ADDENDUM NO. 02

Project: Gulpha Basin Pump Station Improvements
Hot Springs, Arkansas

The Contract Documents dated May 31, 2023, are hereby amended as follows:

JOB NO.
22009
SHEET NO.
C-14

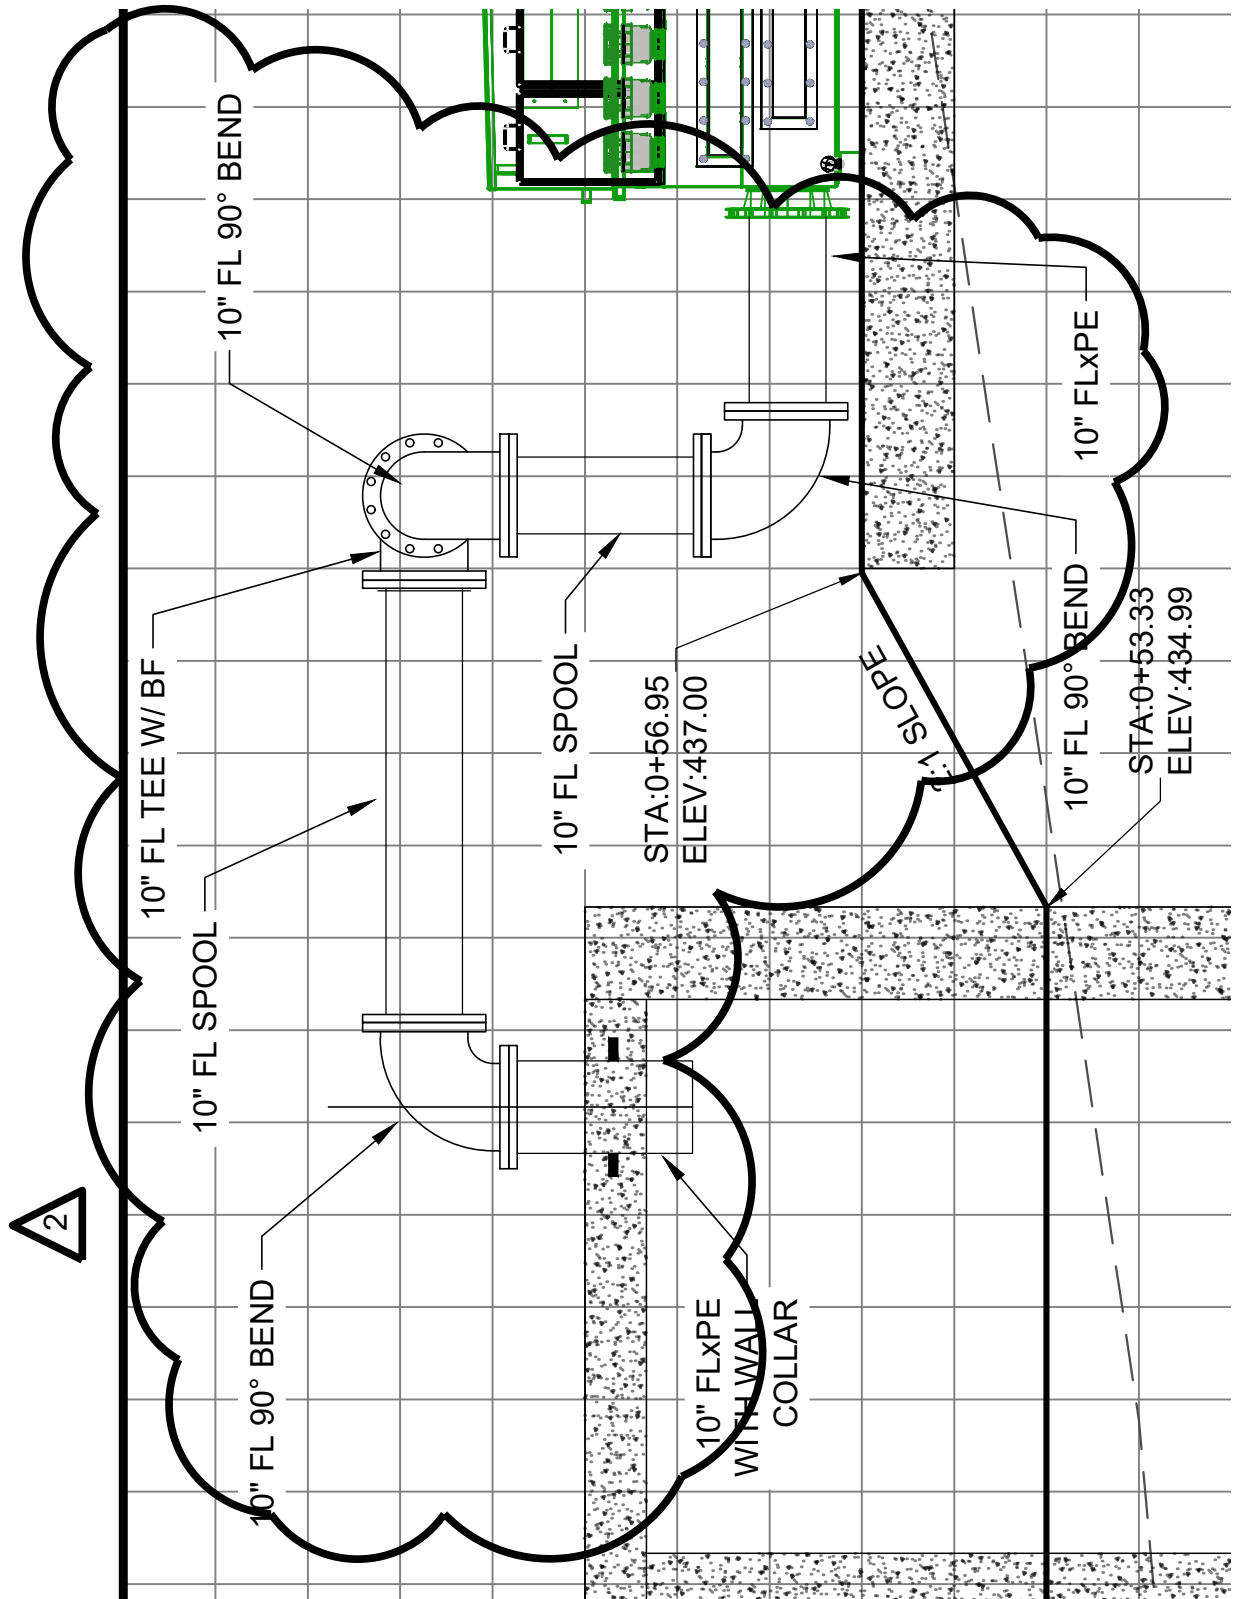
10. Please confirm that the dashed lines in the bottom of the Weir Box, Section 5, represent substantial grouting.
Yes. Reference Addendum No. 02, Item 15 - Drawing C-14 – WEIR BOX DETAIL.

CRIST ENGINEERS, INC. CONSULTING ENGINEERS LITTLE ROCK, ARKANSAS		HOT SPRINGS, ARKANSAS	
		GULPHA P. S. IMPROVEMENTS CITY OF HOT SPRINGS CIVIL STANDARD DETAILS IV	
DESIGNED: CAJ	JOB NO. 22009	DATE JUNE 20, 2023	ADD. NO. 2
DRAFTED: MAB	SCALE: NOT TO SCALE	REF SHEET CZ-4	
CHECKED: CAJ

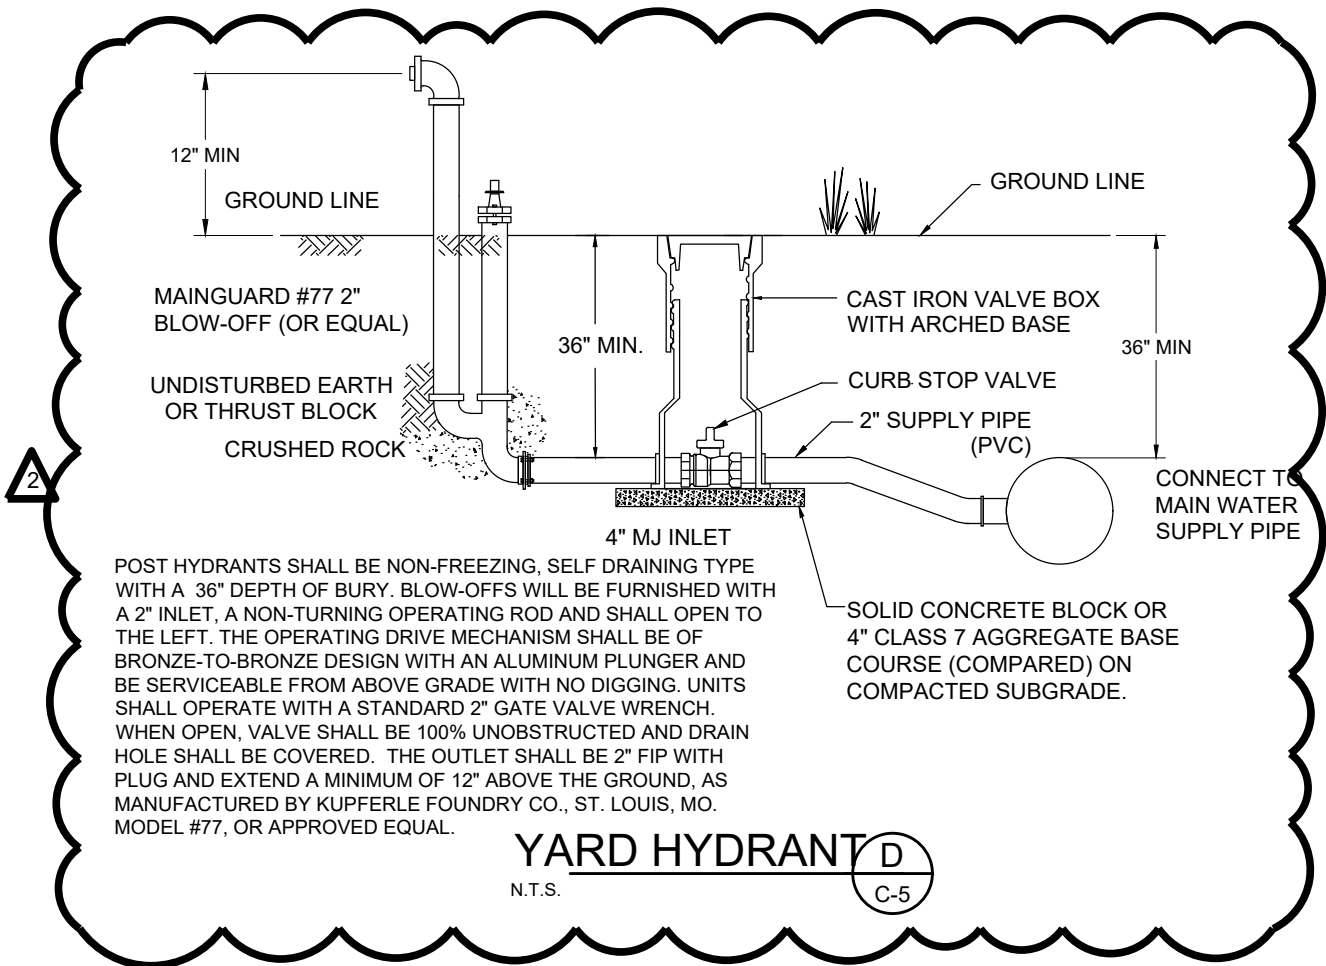
4. Please clarify if piping under new concrete and gravel surfaced areas are subject to the " special roadway conditions " bedding details.
All pipe under asphalt and concrete shall adhere to Detail B, Sheet CZ-4. Reference Addendum No. 02, Item 17 - Drawing CZ-4 – CIVIL STANDARD BEDDING.

DESIGNED: CAJ	JOB NO. 22009	DATE JUNE 20, 2023	ADD. NO. 2
DRAFTED: MAB	SCALE: NOT TO SCALE	REF SHEET CZ-5	
CHECKED: CAJ

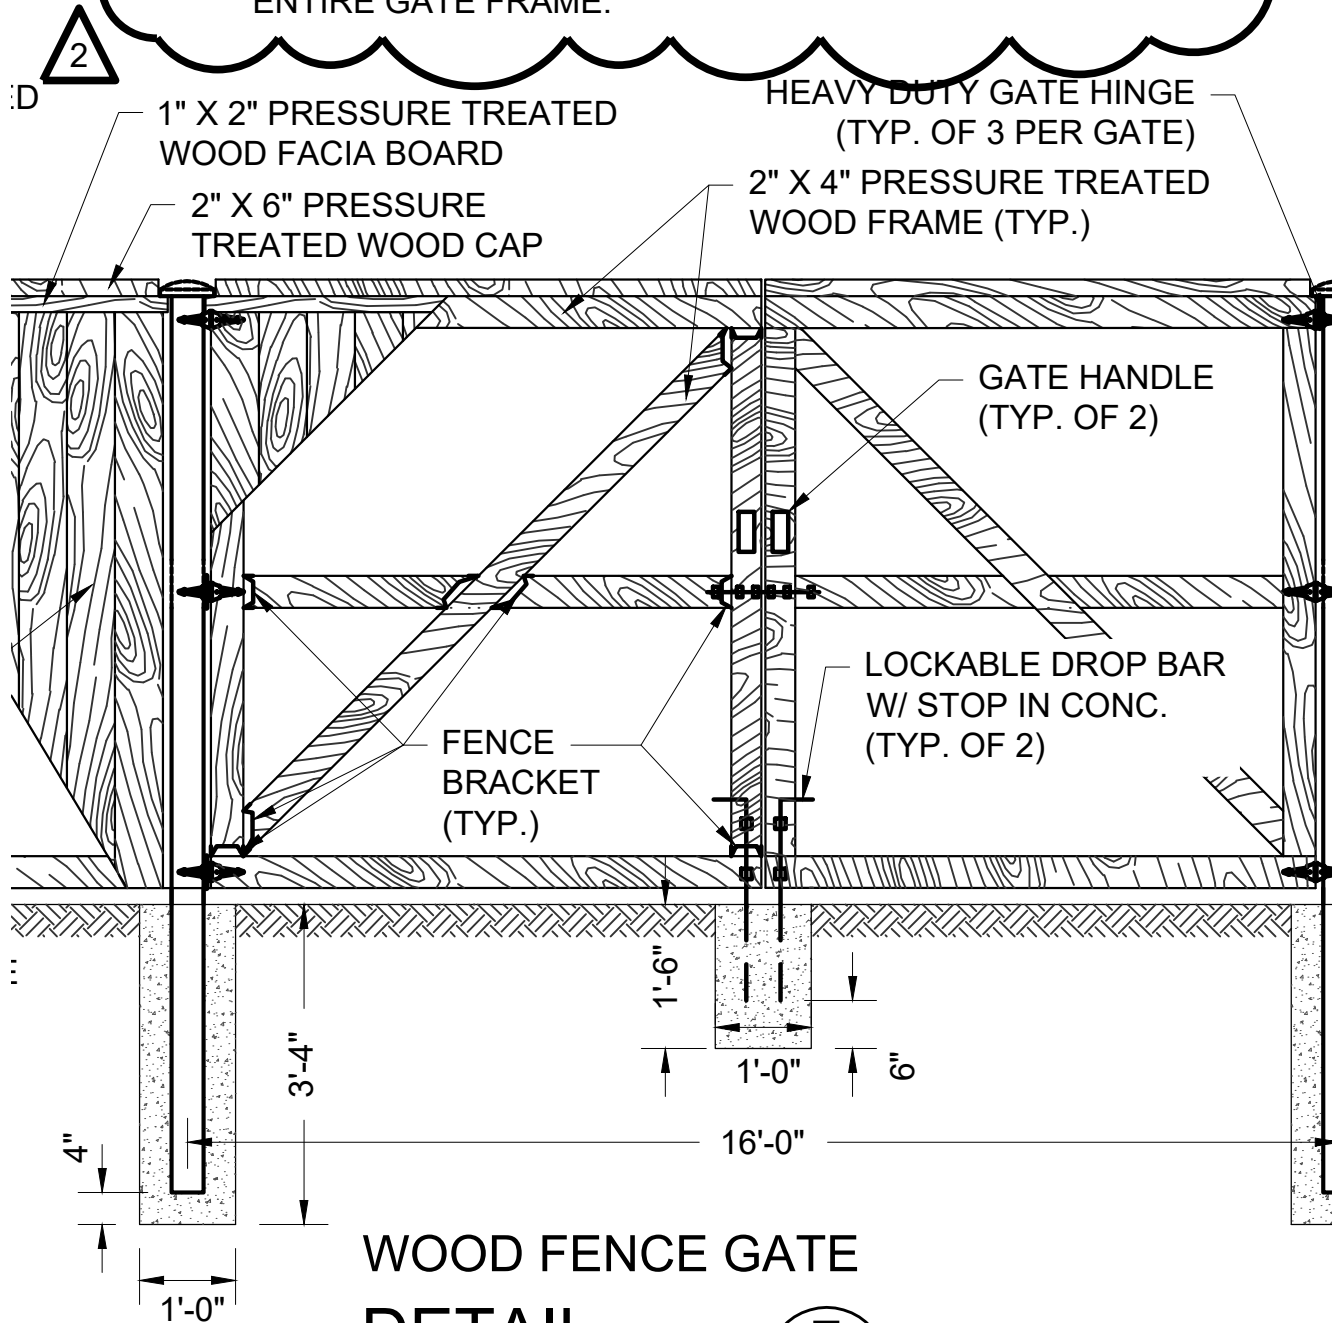
38. Please provide details for 4" Blk. Epoxy Dipped Line Post and Fence Bracket for Stringer mounting.

39. Will it be possible to replace the specified 2" x 4" Wood Frame with metal Frame? The gate width will have issue with sagging and warping.

WOOD GATE FRAME SHALL BE REINFORCED WITH
2"x2"x $\frac{1}{4}$ " ANGLE GALVANIZED STEEL FRAME ANCHORED
BY $\frac{3}{8}$ " GALVANIZED BOLTS, WASHERS AND NUTS, 8" O.C.
ENTIRE GATE FRAME.

CRIST ENGINEERS, INC.	
CONSULTING ENGINEERS		LITTLE ROCK, ARKANSAS	
HOT SPRINGS, ARKANSAS			
GULPHA BASIN PUMP STATION IMPROVEMENTS			
ELECTRICAL BUILDING STRUCTURAL DETAILS			
DESIGNED: MAR	JOB NO. 22009	DATE JUN. 2023	ADD. NO. 2
DRAFTED: SBM	SCALE:	NOT TO SCALE	REF SHEET S-5
CHECKED: MAR

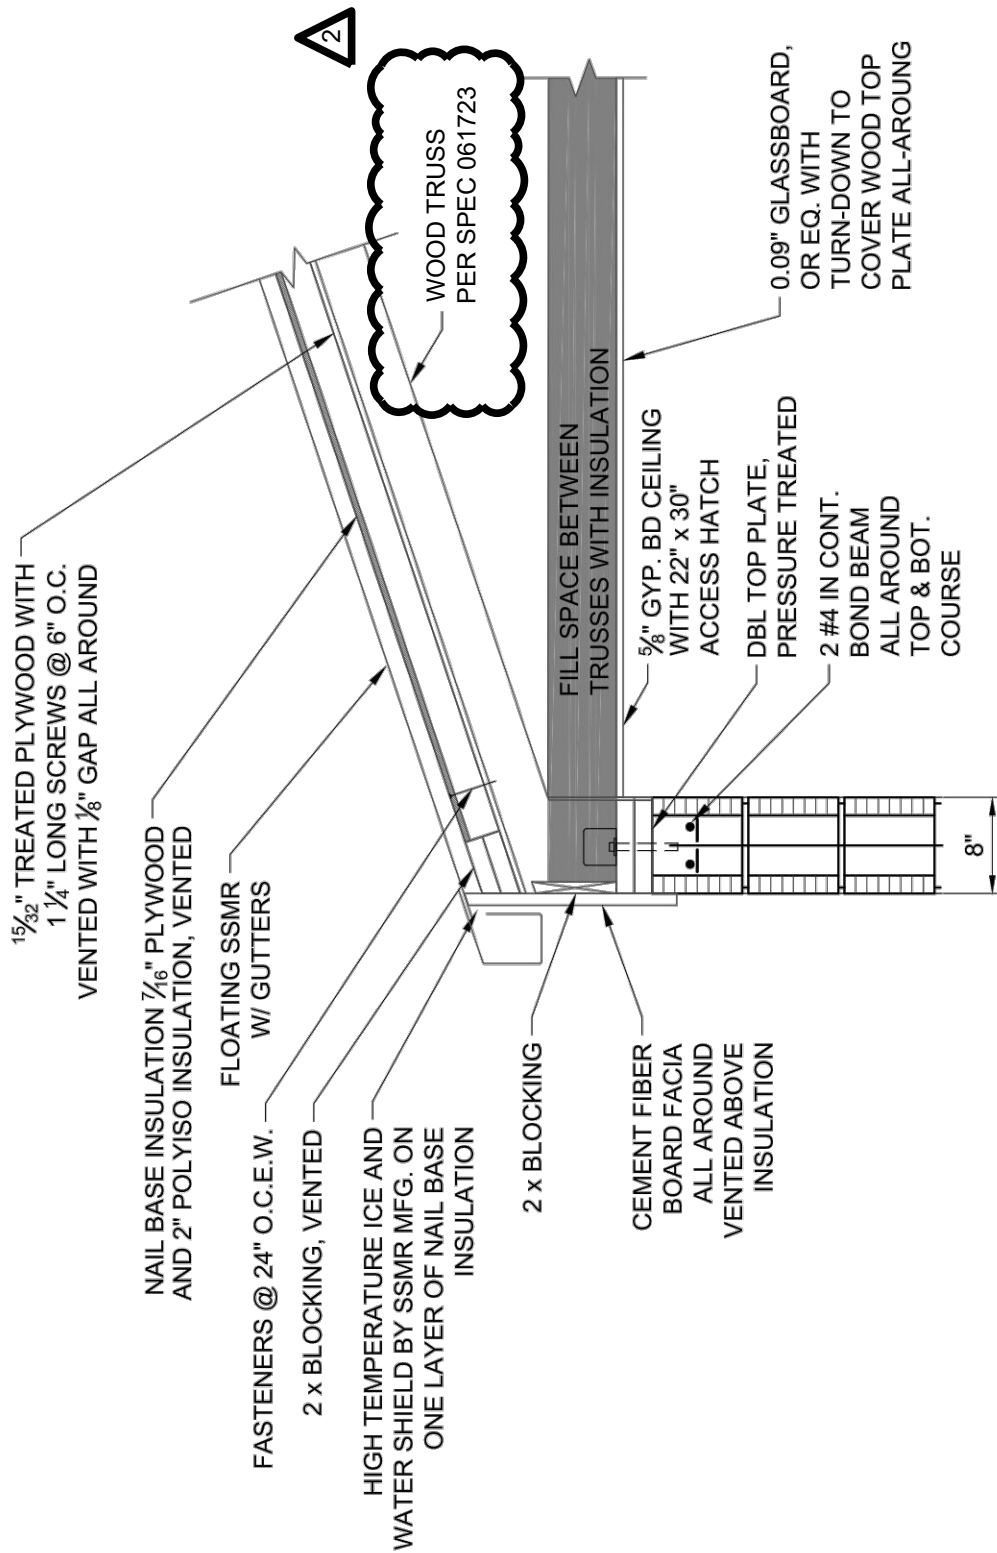
13. Please clarify the material requirement for the trusses used in the Electrical Building. S-5 calls out for Cold Formed Steel Roof Trusses, the Spec Book has DIV 06 17 23, Wood Trusses
Reference Addendum No. 02, Item 19 - [Drawing S-5 – ELECTRICAL BUILDING STRUCTURAL DETAILS.](#)
